**EVALUATION OF GOLDSIM IMPLEMENTATION OF
TOTAL SYSTEM PERFORMANCE ASSESSMENT—
SITE RECOMMENDATION—CNWRA INPUT**

**U.S. Nuclear Regulatory Commission
Contract NRC-02-02-012**

**Center for Nuclear Waste Regulatory Analyses
San Antonio, Texas**

November 2002

Figure 3-1. Frequency of Occurrence of Ratios of TSPA-GoldSim and Inventory data for 26 Radionuclides Considered in the Site Recommendation Model (CRWMS M&O, 2000b) for DOE-owned Spent Nuclear Fuel in Codisposal Waste Package (mass per package, g/package).

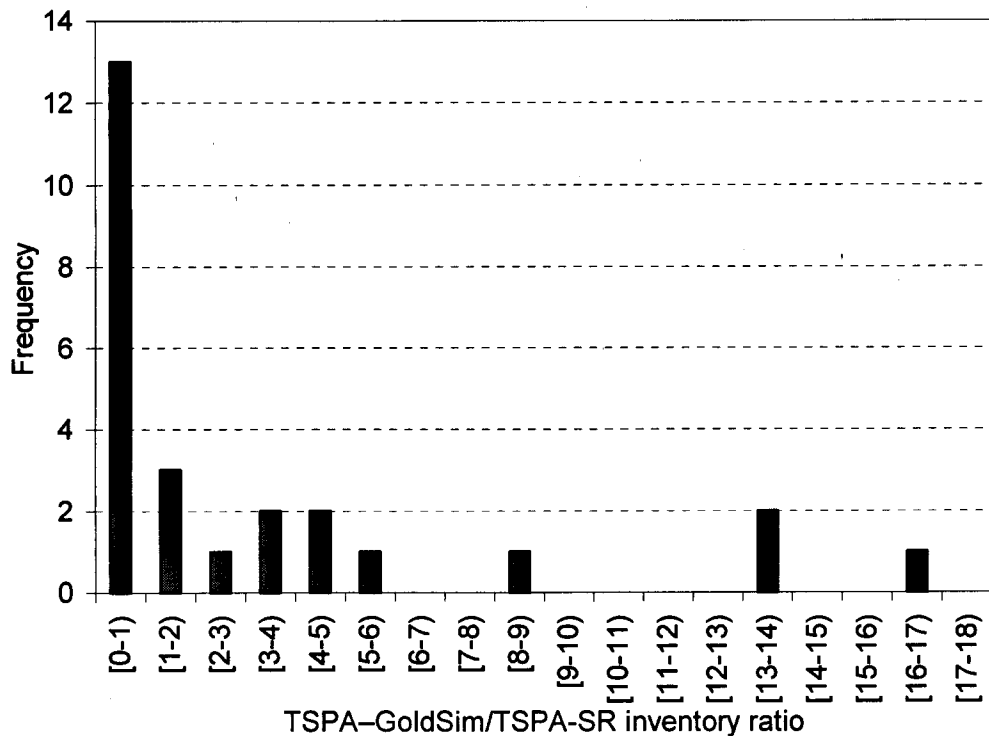
DOE-owned spent nuclear fuel inventory data were compared with data reported in CRWMS M&O (2000b). Inventory ratios of TSPA-GoldSim versus values in CRWMS M&O (2000b) range from 0.63 to 16.51. The same ratios for 13 radionuclides range from 0.63 to 1; 3 ratios are in the 1 to 2 range, and 10 ratios lie between 2 and 16.51. For radionuclides with inventory ratios below unity, 12 ratios are within 10 percent of the values in CRWMS M&O (2000b) [e.g., the value for U-236 is 0.63 of the value in CRWMS M&O (2000b)]. For Np-237, I-129, and Tc-99 the ratios are 8.9, 3.22, and 3.94. Detailed comparison results are presented in Figure 3-1.

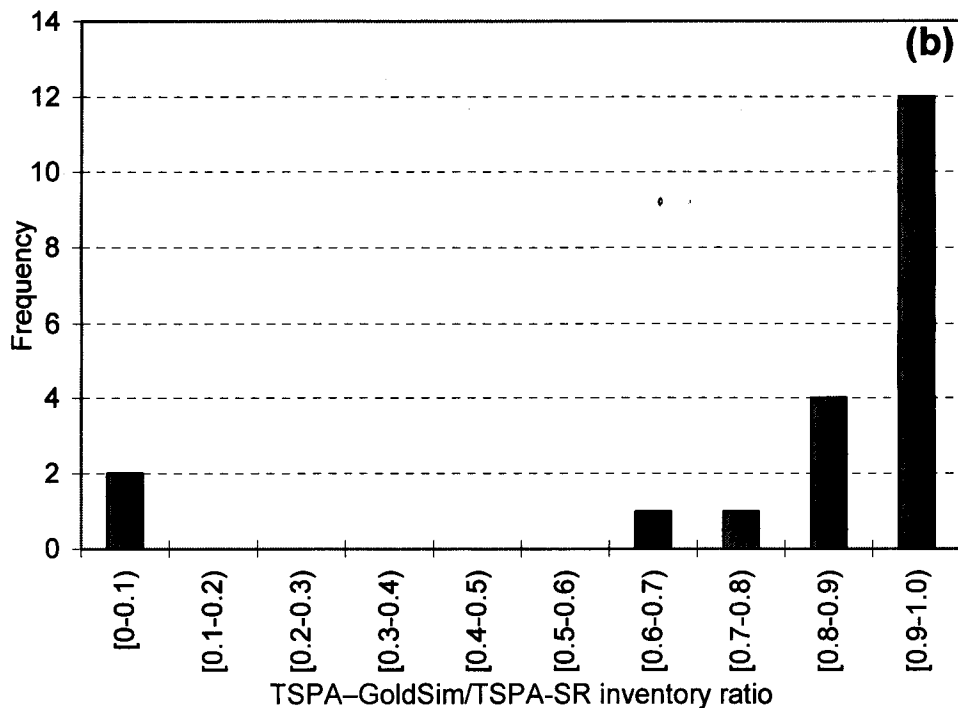
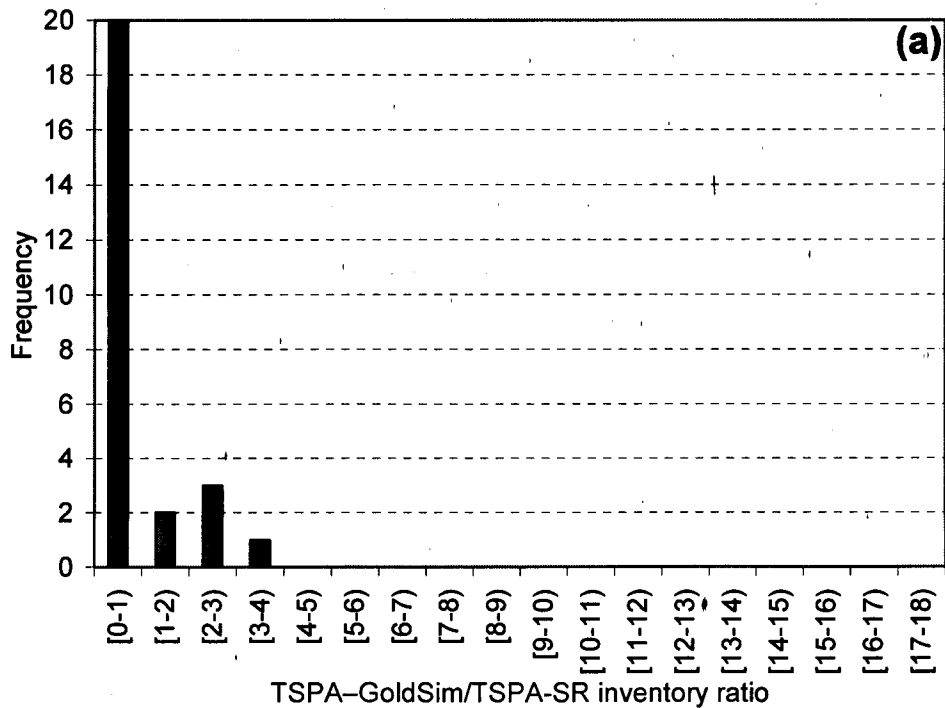
High-level waste glass inventory data in the SR00_037ne6.gsm file were compared with the data in CRWMS M&O (2000b). Ratios of TSPA-GoldSim and data in CRWMS M&O (2000b) range from 0.02 to 3.01; the ratios for 20 radionuclides are within the 0.002 to 1 range, and for 6 radionuclides, within the 1 to 3.01 range. Detailed comparisons are presented in Figure 3-2. Figure 3-2(b) presents a comparison for ratios in the less than unity range.

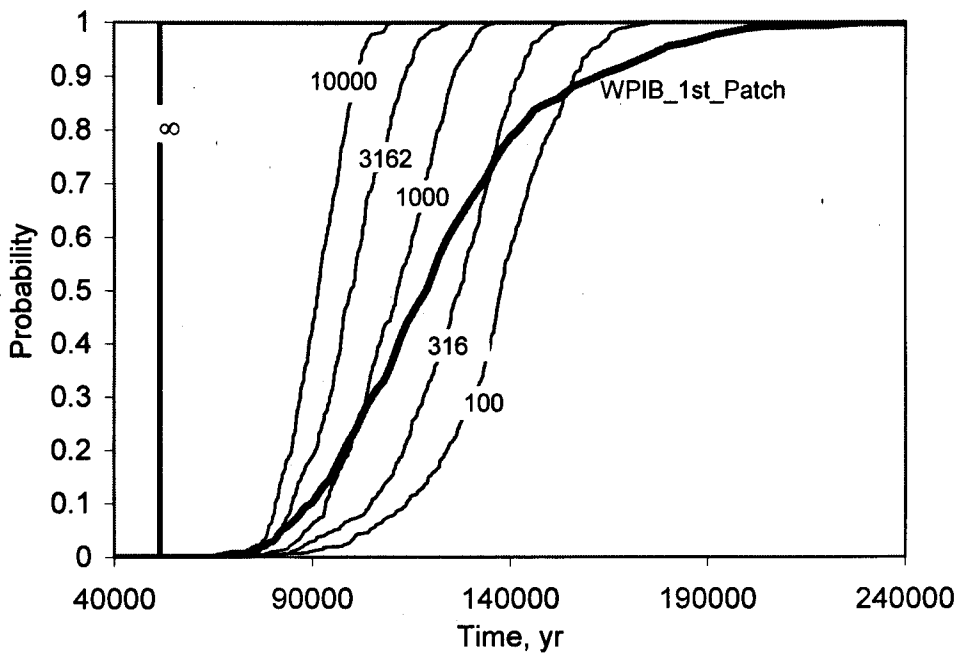
Figure 3-9 includes a comparison of the fraction of waste packages failed by general corrosion in the TSPA–GoldSim code median run to our independent computations. The TSPA–GoldSim code data are available in the variable named WPIB_1st_Patch of the file SR00_037ne6.gsm. A significant difference is noted. Because the WAPDEG is implemented as a dynamic link library external to TSPA–GoldSim code, it is not possible to track the source of the differences by browsing the SR00_037ne6.gsm file. Accounting for the variation in the relative humidity is not sufficient to explain the differences. It is suspected that the source of the difference is in the algorithm for the sampling of corrosion rates.

We conclude that it is incorrect to use the first-patch failure curves (such as those shown in Figure 3-9) to measure the performance of the system for two reasons: (i) convergence is not achieved by consideration of 1,000 patches and (ii) the convergence function is solely dependent on the maximum corrosion rate. It has been argued elsewhere (CRWMS M&O, 2000g) that 1,000 patches are enough to guarantee convergence of the first-patch failure curve, but this conclusion is in contradiction with the simplified computations in this report. It must be noted, however, that infinite discretization of the waste package surface lacks physical meaning. Also, the variability in the corrosion rates measured in the Long-Term Corrosion Test Facility may be valid only for patches similar in area to the test samples. In other words, it may not be appropriate to assume the same distribution of corrosion rates on much smaller areas than those of the coupons of the weight-loss experiments. Within the TSPA–GoldSim code implementation further exploration is recommended of the factors determining the shape of the first-patch failure curve to sort this apparent convergence problem.

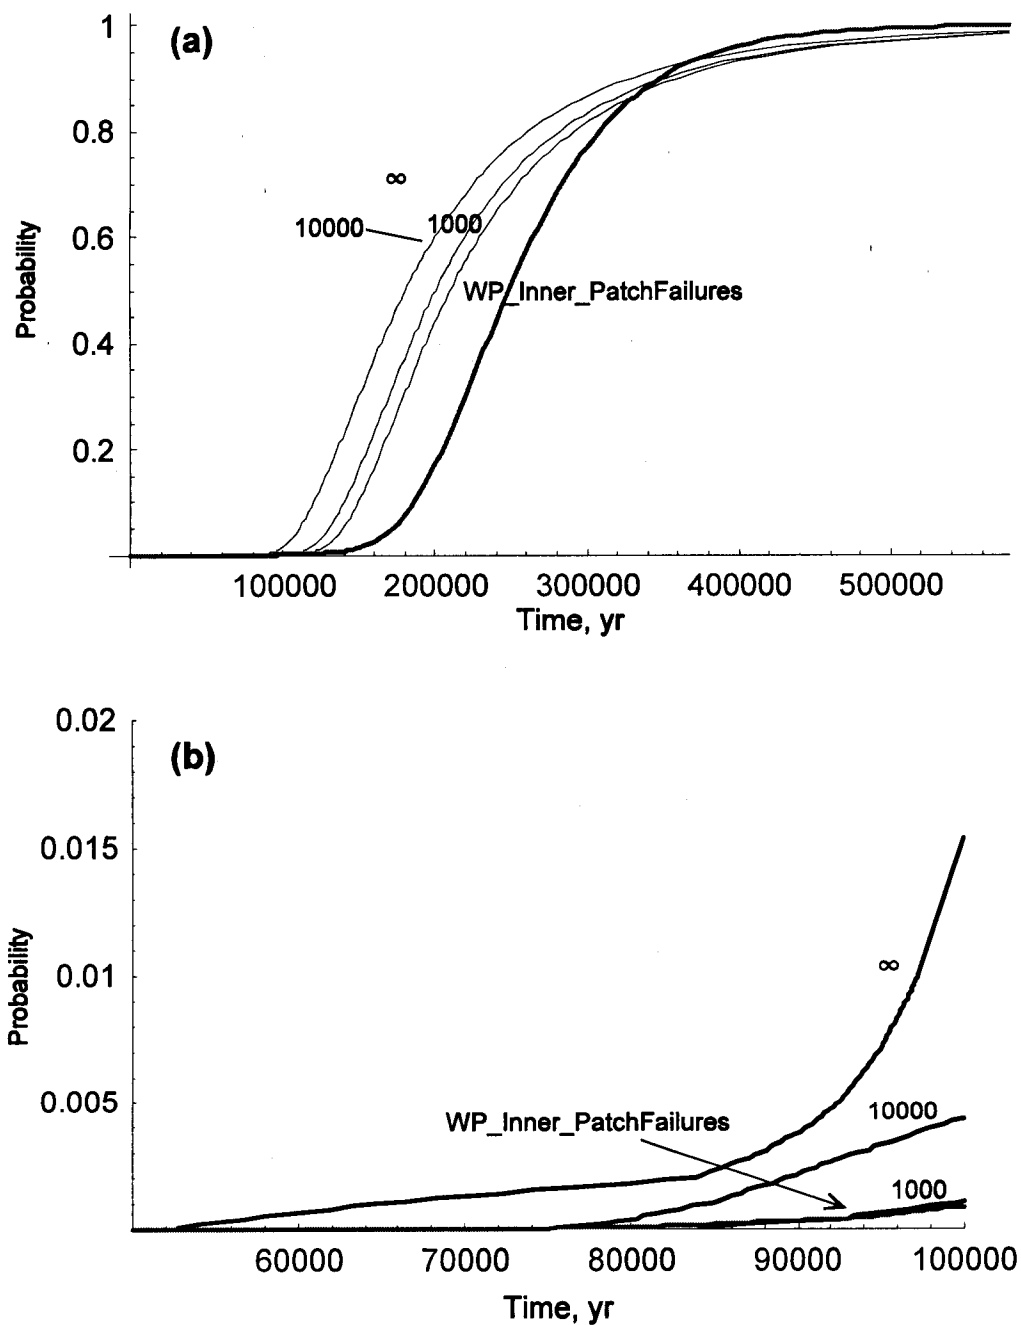
In Figure 3-10, important differences are noted between the limiting curve for the fraction of failed patches versus time and those curves derived when 1,000 or 10,000 patches are considered. The difference is significant, especially in the first 100,000-year period [Figure 3-10(b)]. There is good agreement between data contained in the variable WP_Inner_PatchFailures of the TSPA-GoldSim code median run and the simplified computations in the 100,000-year period. Significant disagreement is noted for longer periods, however. Differences in the sampling strategy (e.g., selection of the inside-outside corrosion rate independently from the outside-inside rate and modeling of the waste package Alloy 22 wall as composed of two virtual independent layers) are not envisioned enough to account for the disagreement. It is possible, however, the collection of corrosion rates used as the starting point in the simplified computations (those defined in the file WDdA22SR00.cdf; see Figure 3-8) may differ from the rates actually used in the TSPA-GoldSim code median run.

We concluded that the use of 1,000 patches may not be enough to guarantee convergence of the curve for the fraction of patches failed versus time. As previously mentioned, however, care must be applied to use a distribution of corrosion rates to infinitely small patches because (i) the experimental distribution of corrosion rates has associated an intrinsic scale fixed by the area of the coupon samples of the weight-loss experiments, and (ii) certain model-hypotheses cease to be valid (e.g., the activation of inside-outside corrosion after first-patch penetration). Although the convergence argument for the selection of 1,000 patches offered in CRWMS M&O (2000g) may not be valid, the discretization into 1,000 patches may be justifiable on the basis of the size of the weight-loss coupons used to derive a distribution of corrosion rates.

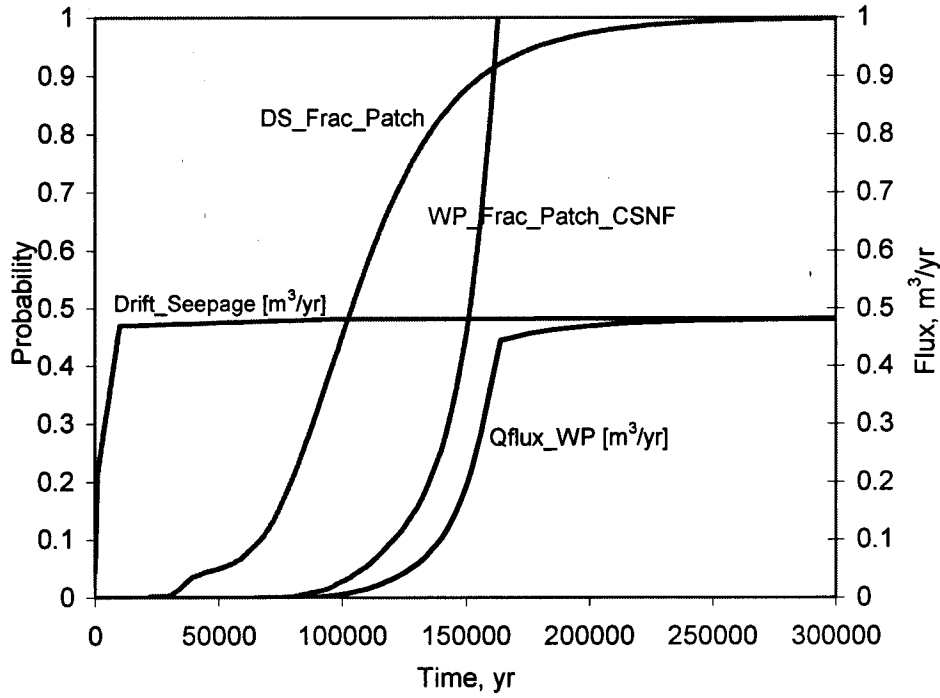
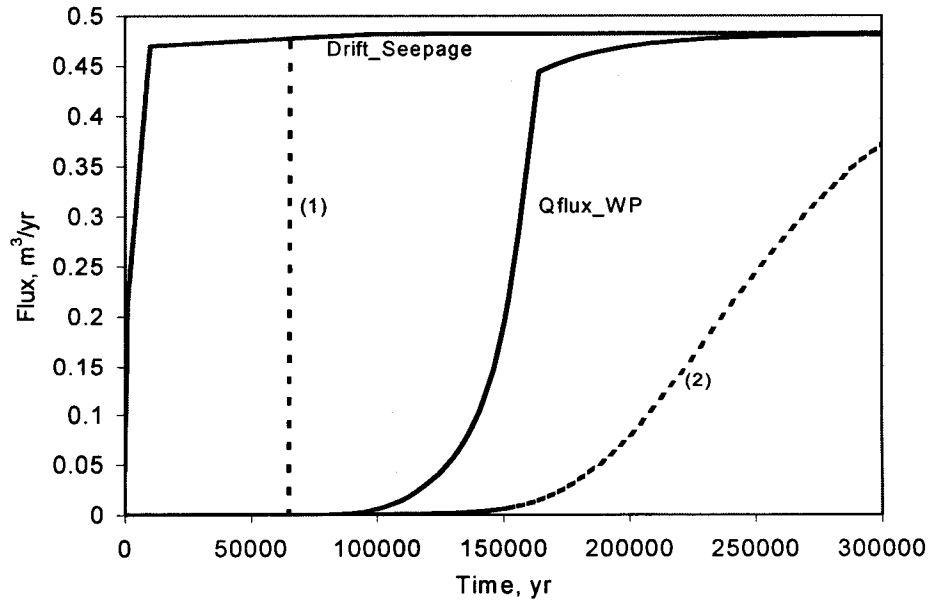
Figure 3-12 is provided to assess the significance of the noted inconsistency in TSPA–GoldSim code. Figure 3-12(a) presents the derivation of the amount of water for the computation of advective release within the TSPA–GoldSim code and the data for the median case run (SR00_037ne6.gsm file). The variable $Drift_Seepage$ tracks the amount of seepage at the drift in m^3/yr units. This seepage rate is modulated by the fraction of patches failed on a drip shield, DS_Frac_Patch , and the axial degraded length of a waste package, $WP_Frac_Patch_CSNF$. The resulting water flux, $Q_{flux_WP} = Drift_Seepage \times DS_Frac_Patch \times WP_Frac_Patch_CSNF$, is the amount of water available for the advective release of radionuclides. Figure 3-12(b) includes fluxes that would be derived if more consistent definitions were applied. For example, the dotted line (1) would be obtained if the approach explained in CRWMS M&O (2000h) were indeed implemented to determine the amount of water available for advective release. The dotted line (2) would be obtained if the fraction of patches failed, for both the drip shield and the waste package, was used as a factor to modulate the seepage rate at the drift. Clearly, the current implementation in the TSPA–GoldSim code is conservative with respect to option (2). The current implementation however, is not conservative with respect to the proposed approach in the DOE documentation. Besides, the variable $WP_Frac_Patch_CSNF$ lacks physical meaning, as previously explained.

Figure 3-13. Iron Oxide Colloid Stability Diagram, Showing the Two Lines (Dashed) Represented by Condition B. the Solid Dot Represents Conditions at 100,000 Years for the Median Value Case.

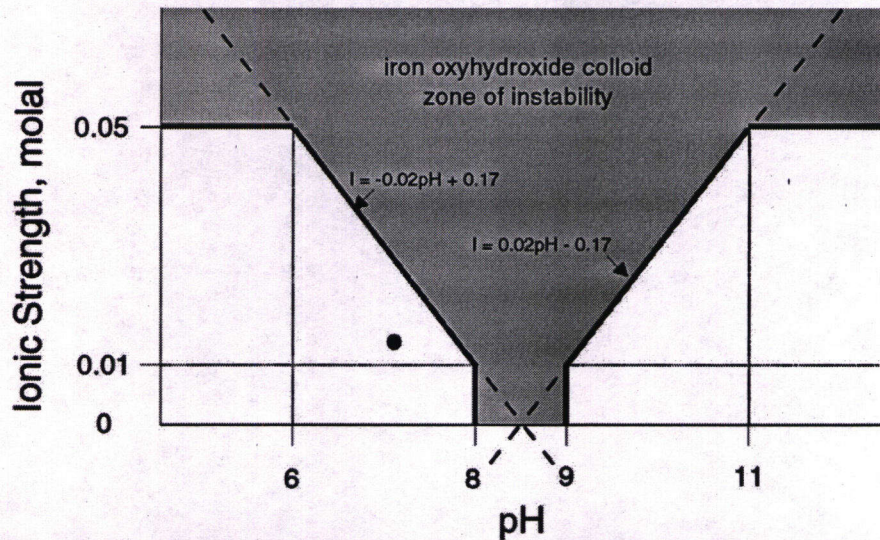
Condition B is represented graphically in Figure 3-13, which is modified from Figure 11 in CRWMS M&O (2000l) and is also reproduced as Figure 7 in the CRWMS M&O (2000k). In combination with Condition A, Condition B is intended to set the iron-oxide colloid mass to its minimum value if pH and ionic strength lie in the shaded zone of instability. The intended abstraction is that if ionic strength is between the upper and lower threshold values of 0.01 and 0.05 molal (Condition A) and above the two sloping lines between pH 6 and 8 and between pH 9 and 11, iron-oxide colloids are unstable, and the minimum concentration will be selected. The two sloping lines are represented by the equations $I = -0.02 \cdot \text{pH} + 0.17$ and $I = 0.02 \cdot \text{pH} - 0.17$. It can be seen in Figure 3-13 that the condition that ionic strength be above one line or the other applies to all positive values of ionic strength because the lines intersect on the zero axis. Therefore, Condition B will always be true (value of one in the TSPA-GoldSim code expressions), and the minimum iron-oxide colloid concentration will incorrectly be chosen for all conditions with ionic strength between 0.01 and 0.05 molal. The operator in Condition B should be AND. For example, a correct expression for condition_B_WP would be
